Re: RI Work Plan Addendum
Former Belle Cleaners
40 Purchase Street, Rye, NY
Site ID 360086

On behalf of West Turnpike, Inc., CA RICH provides this Work Plan Addendum to address the comments included in your letter dated August 20, 2007 (copy attached).

Sampling Locations

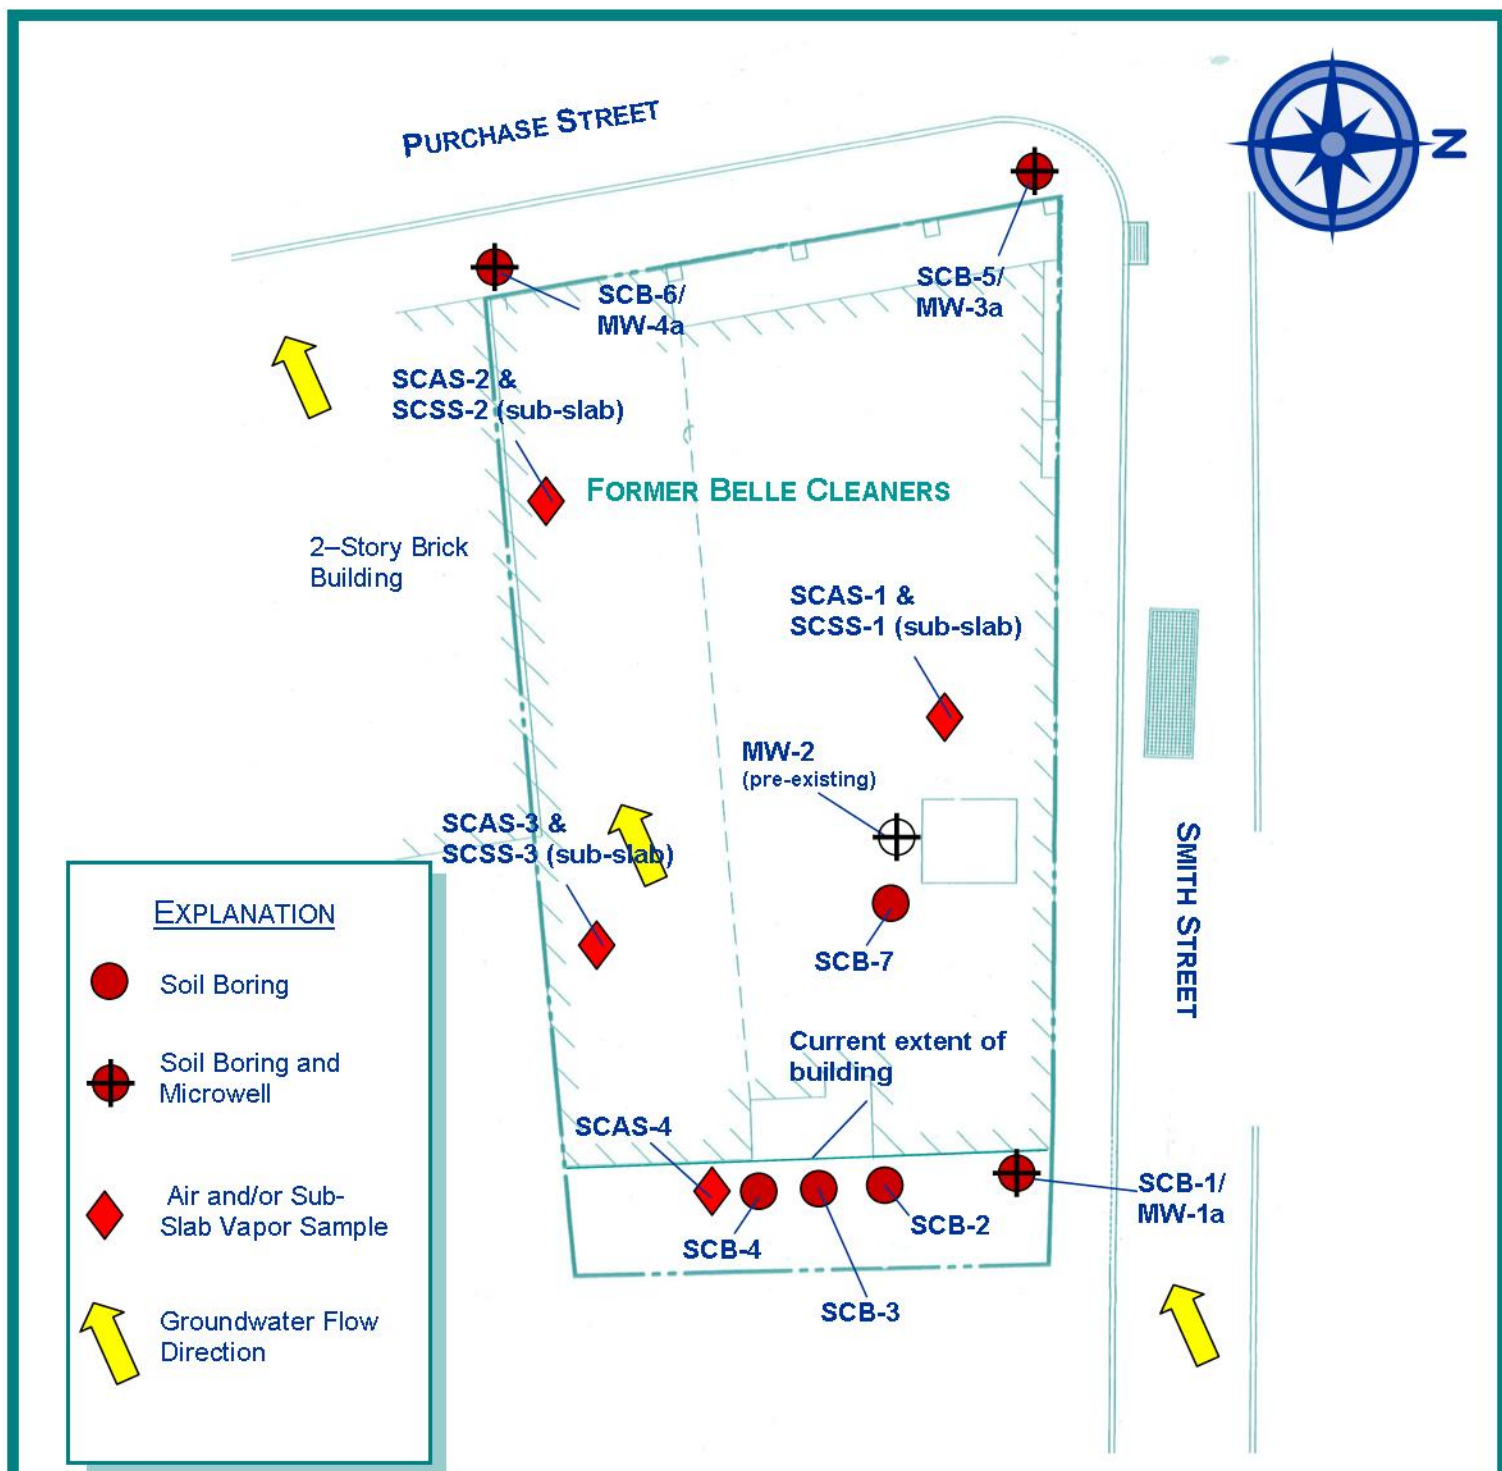
Due to the historical presence of VOCs in the groundwater, subsurface soil and soil gas, additional vapor samples should be collected to evaluate the potential for site-related vapor migration to off-site buildings. Air samples collected for the vapor intrusion investigation in commercial buildings should be collected for an 8-hour period and analyzed as per EPA method TO-15.

CA RICH will add an additional sub-slab and indoor air sampling location (to bring the total to three) within the basement of the building. Indoor air samples will be collected over an eight-hour period.
